# MANDATORY SERVICE BULLETIN

## MSB 50-012

Replacement of the Main Landing Gear Retaining Rings.  
ATA-Code: 32-00

## WI-MSB 50-012

1	Pull and tag the GEAR circuit breaker to prevent inadvertent landing gear operation.
2	<p>Locate the retaining rings on the backside of the MLG. See Detail Views A and B shown in below figure showing the LH MLG:</p>  <p style="text-align: center;">Figure 1: MLG Backside Retaining Rings</p>

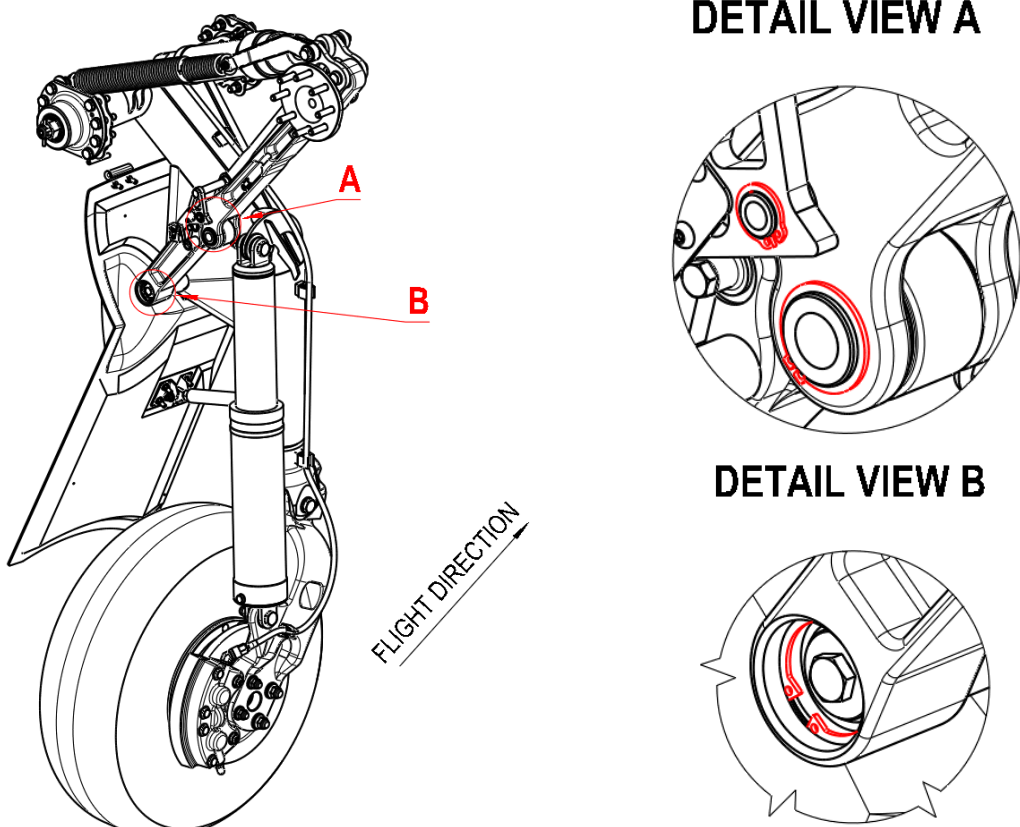
3	<p>Replace the Retaining Rings in Detail View A with:</p> <ul style="list-style-type: none"><li>• DIN471-20-MZP</li><li>• DIN471-10-MZP</li></ul> <p>Replace the Retaining Ring in Detail View B with:</p> <ul style="list-style-type: none"><li>• DIN472-30X1.2-MZP</li></ul> <p>Replace only one Retaining Ring at a time!</p> <p style="text-align: center;"><b>CAUTION</b></p> <p style="text-align: center;">Do not remove or move shafts while replacing retaining rings</p> <p>Clean the grooves of the bearing shafts. Inspect the folding stay and bearing shafts for general condition before installing the new retaining rings.</p> <p style="text-align: center;"><b>NOTE</b></p> <p style="text-align: center;">Any repair / replacement / further inspection of the folding stay, and/or the bearing shaft needs, must be completed before you proceed with the next steps.</p> <p style="text-align: center;"><b>NOTE</b></p> <p style="text-align: center;">Do not overstretch the retaining rings during installation. Open the rings only enough to fit over the shaft when installing.</p> <p>Install the new retaining rings. Make sure the retaining rings properly engage into the grooves of the bearing shafts.</p>

Figure 2: MLG Frontside Retaining Rings

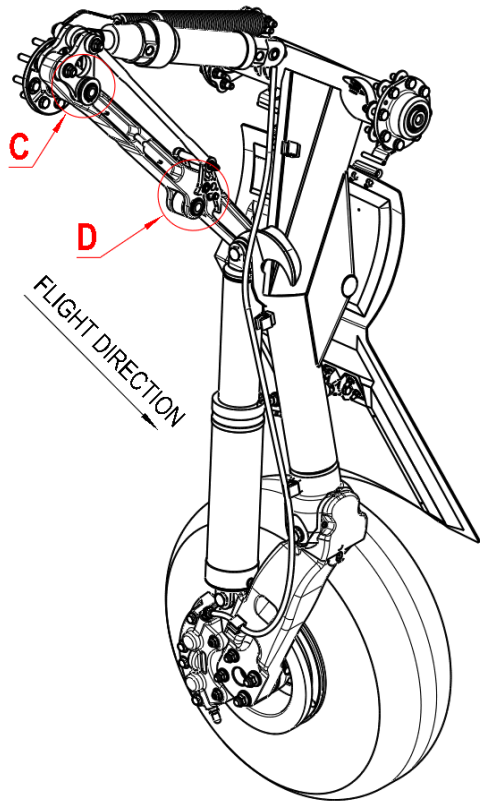
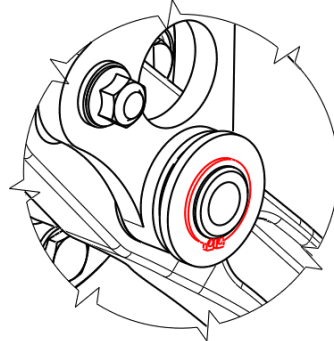
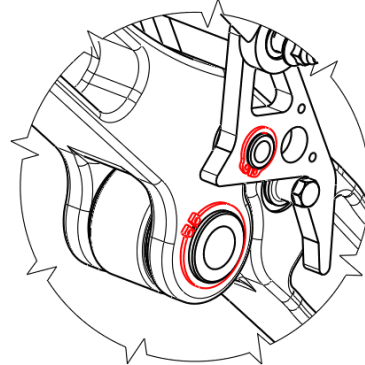
Locate the retaining rings on the frontside of the MLG. See Detail Views C and D shown in below figure showing the LH MLG:

5	<p>Replace the Retaining Ring in Detail View C with:</p> <ul style="list-style-type: none"> <li>• DIN471-20-MZP</li> </ul> <p>Replace the Retaining Rings in Detail View D with:</p> <ul style="list-style-type: none"> <li>• DIN471-20-MZP</li> <li>• DIN471-10-MZP</li> </ul> <p>Replace one Retaining Ring at a time!</p> <p style="text-align: center;"><b>CAUTION</b></p> <p style="text-align: center;">Do not remove or move shafts while replacing retaining rings.</p> <p>Clean the grooves of the bearing shafts. Inspect the folding stay and bearing shafts for general condition before installing the new retaining rings.</p> <p style="text-align: center;"><b>NOTE</b></p> <p style="text-align: center;">Any repair / replacement / further inspection of the folding stay, and/or the bearing shaft needs, must be completed before you proceed with the next steps.</p> <p style="text-align: center;"><b>NOTE</b></p> <p style="text-align: center;">Do not overstretch the retaining rings during installation. Open the rings only enough to fit over the shaft when installing.</p> <p>Install the new retaining rings. Make sure the retaining rings properly engage into the grooves of the bearing shafts.</p>
